Capitol Area Architectural and Planning Board

Date: June 4, 2026
To: Members of the Capitol Area Architectural and Planning Board (CAAPB)
From: Peter Musty, Principal Planner and Administrator of the Rules for Zoning and Design

Proposed Design: University Rice Commons & Mobility Hub

Attachment B: Proposed Concept

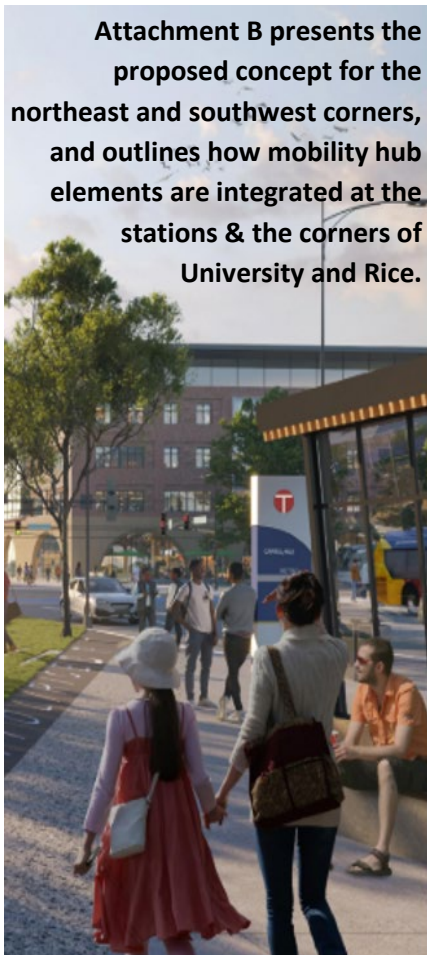
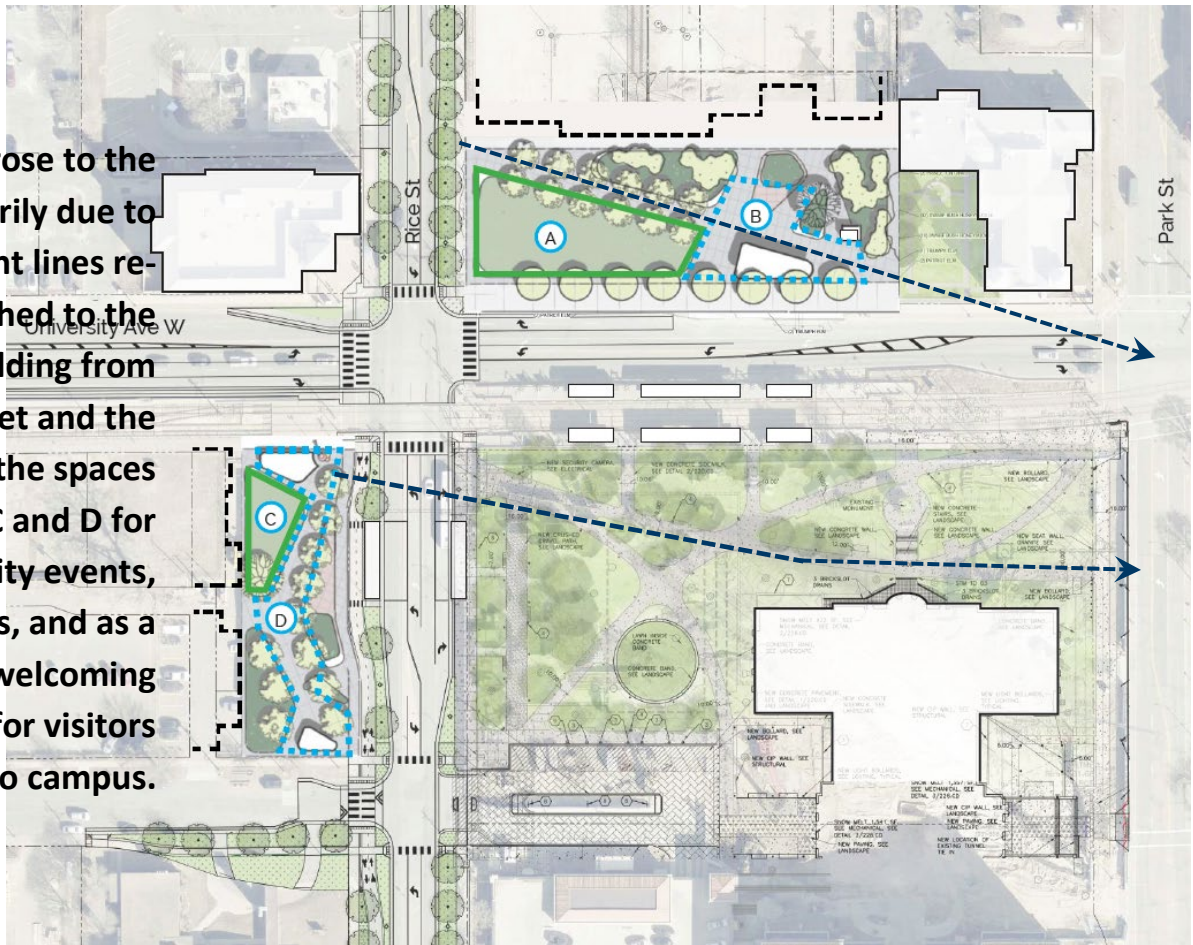
"The CAAPB Architectural Advisors have reviewed and support the proposed conceptual design for the Lot C and Lot AA spaces at the corner of Rice Street and University Avenue. The concept development for the Capitol Rice Commons proposes a viable framework for integrating the Capitol campus with the surrounding urban fabric. By building upon the axial principles of Cass Gilbert's 1903 plan, the proposed design establishes a formal orientation that prioritizes sightlines to the Capitol dome while accommodating contemporary multimodal functions. The programmatic division of Lots C and AA into specific zones for transit and public use addresses the practical requirements of the site, though the density of transit infrastructure necessitates careful spatial coordination to maintain the intended civic atmosphere. The inclusion of BRT amenities and sustainable site features, such as regional stormwater management, aligns with current urban standards and CAAPB goals for the spaces. However, the long-term utility of these spaces will be contingent upon the consistent implementation of an operations and maintenance plan that is compatible with FMD resources and capabilities. Overall, the proposed design provides a thoughtful and grounded approach to the district's evolution, requiring continued focus on balancing transit efficiency with the campus's historical character as the project moves into detailed design and implementation." (received May 20, 2026)

LMC’s Support for the Project - We believe this development represents a net positive for the Capitol Area. Active green space with trees, seating, and multimodal transportation options can transform a challenging urban corner into a welcoming public amenity. We also see potential for this project to strengthen the connection between our facility and the Capitol complex, which would be a benefit to our staff and our members.

Our Key Concerns - While we are broadly supportive of the project, we want to ensure the CAAP Board give serious attention to the following priorities:

- **Operations and Maintenance:** The long-term success of this project will depend on consistent maintenance and active oversight. We encourage the Board to establish clear standards and dedicated resources for ongoing maintenance.
- **Visibility and Sight Lines:** The design should preserve sight lines throughout the park spaces. Lighting, landscaping, and structures should be arranged to avoid creating concealed areas, especially along the pedestrian routes our staff and members use to access the Capitol outside of standard business hours.
- **Safety and Security.** We encourage coordination with Capitol Security and local law enforcement on an ongoing operational security plan.

“Christ on Capitol Hill’s support for the preferred concept has been clear: additional livable public green space, permit-able areas for community gatherings for hospitality and advocacy events, as well as intentional intergenerational neighborhood amenities along University to serve our diverse neighbors.

Feedback from the congregation has also included the desire for a small, fenced play area with a public restroom as well as a small ice-skating rink. These areas would send a clear message of inclusion, welcome, beauty and joy to our block.

The church’s Peace Garden (adjacent to Lot C) stands as a beacon of life and hope, investing in this vision, with a mix of benches, native plants, and pollinator-friendly landscape. We would like this property to blend permeably (removing large trees along state-own property line) with the preferred concept, allowing for neighbors to feel both peace and purpose here.” (Received May 21, 2026)

The Board approves the direction of the design presented in Attachment B, and supports further development of the schematic drawings and plan for implementation to be considered at a future board meeting.
